**NORTH LANTAU REFUSE TRANSFER STATION
CONSULTANCY STUDY**

INITIAL ENVIRONMENTAL
IMPACT ASSESSMENT REPORT

April 1995

Figure 3.1

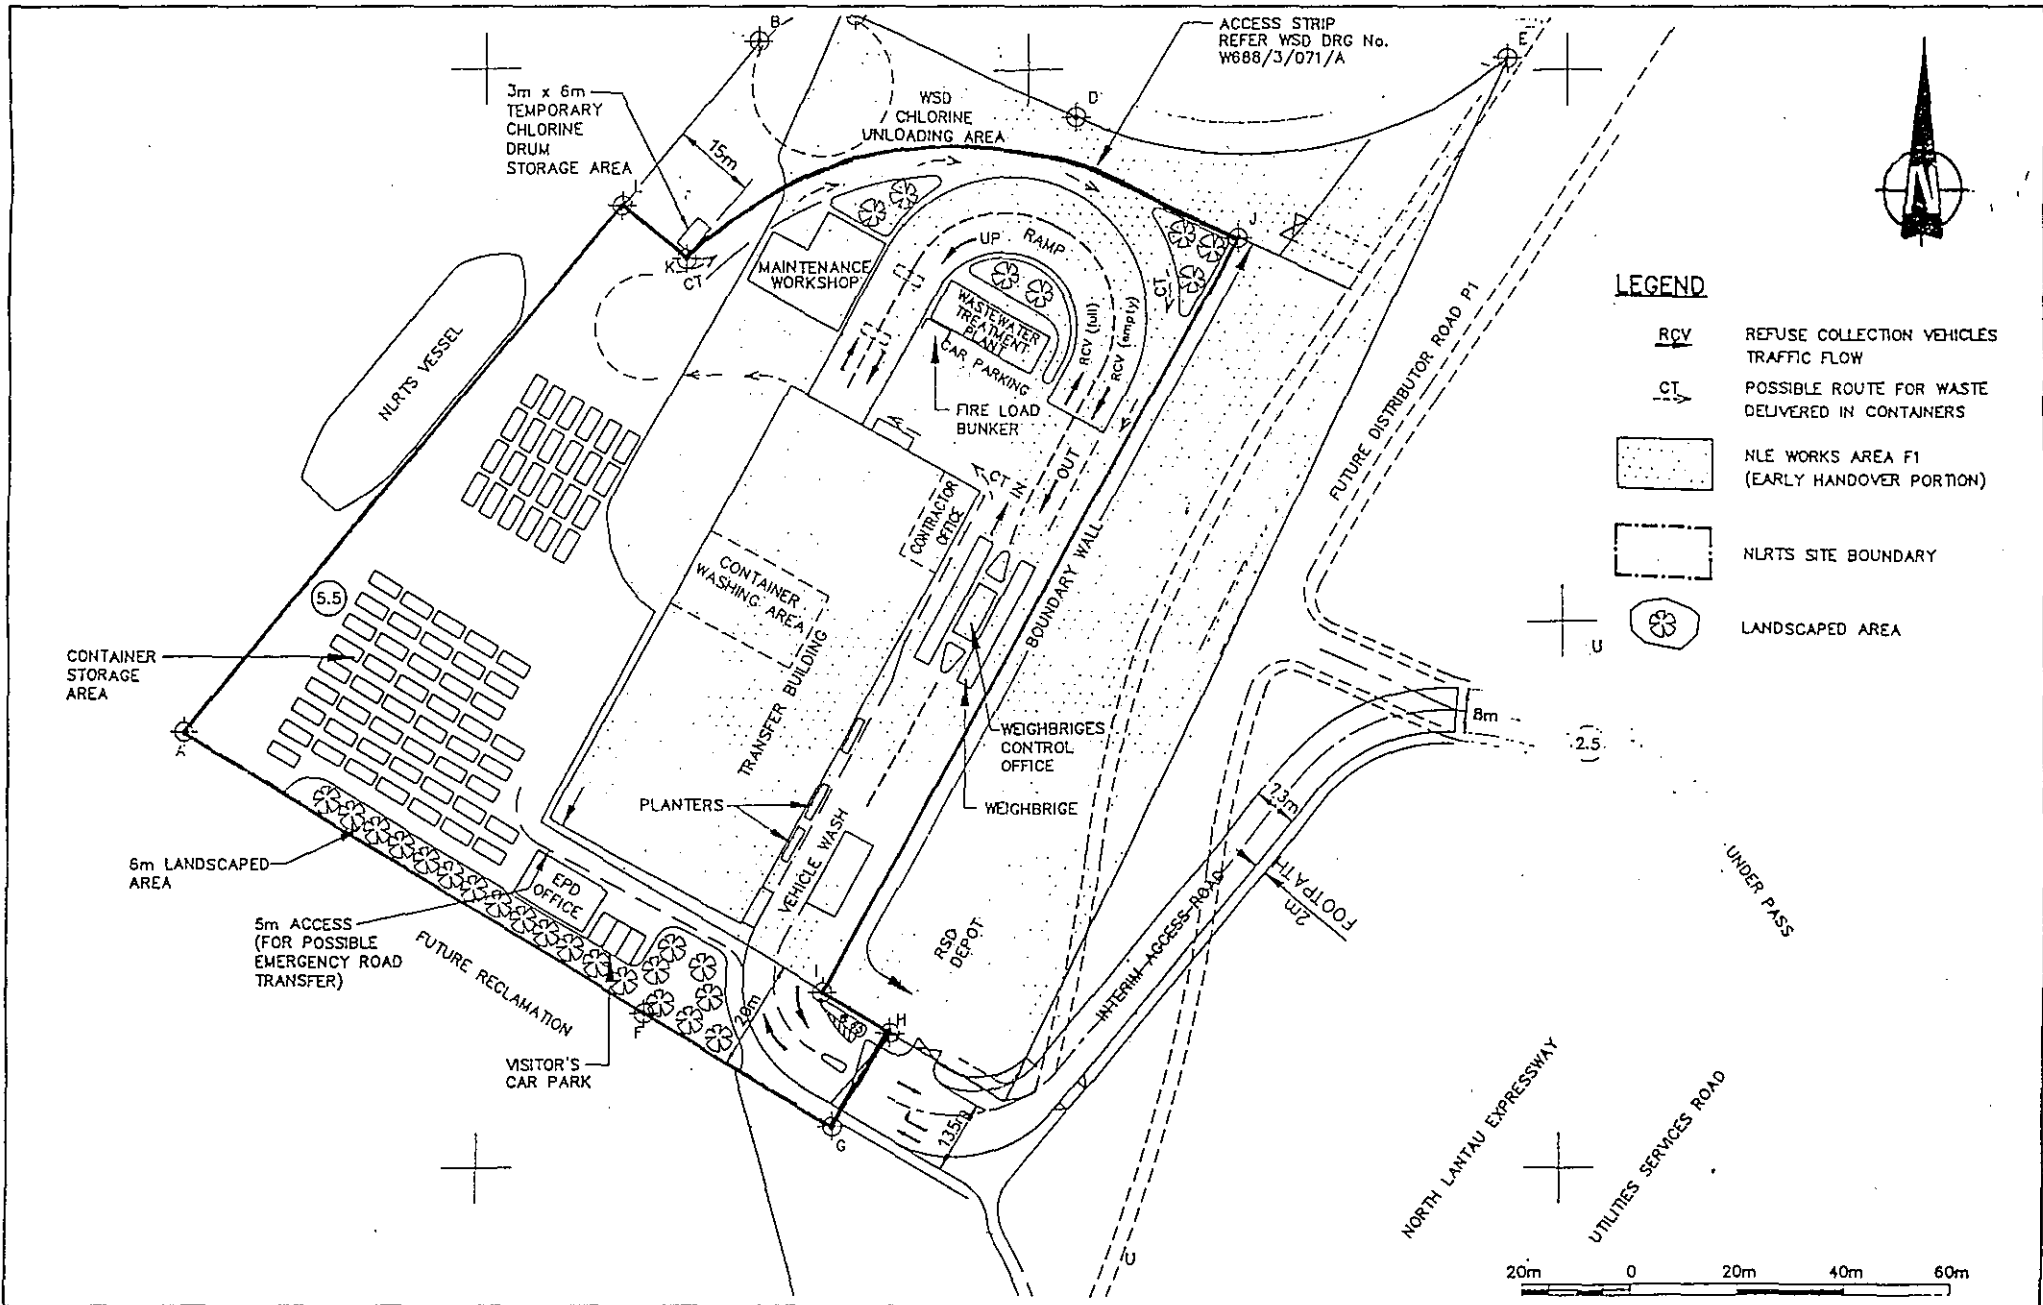
Para. 7.2.2 Line 2 & Figure 3.1

The present zoning of the NLRTS is Government Reservation 'G' on the Siu Ho Wan Layout Plan No.: L/1-SHW/C, please amended the context accordingly.

Para. 7.2.7 & Figure 3.1

Comment noted. Text will be amended to include this information.

Comment noted. We are advised that it is impossible to reserve a strip of land to the south-east of the site for landscaping due to space constraints. A boundary wall of approximately 2 - 2.5 m height will be provided though this will offer minimal screening to elevated receivers on the NLE. TDD have advised there would be no landscaping along the NLE/ARL corridor.
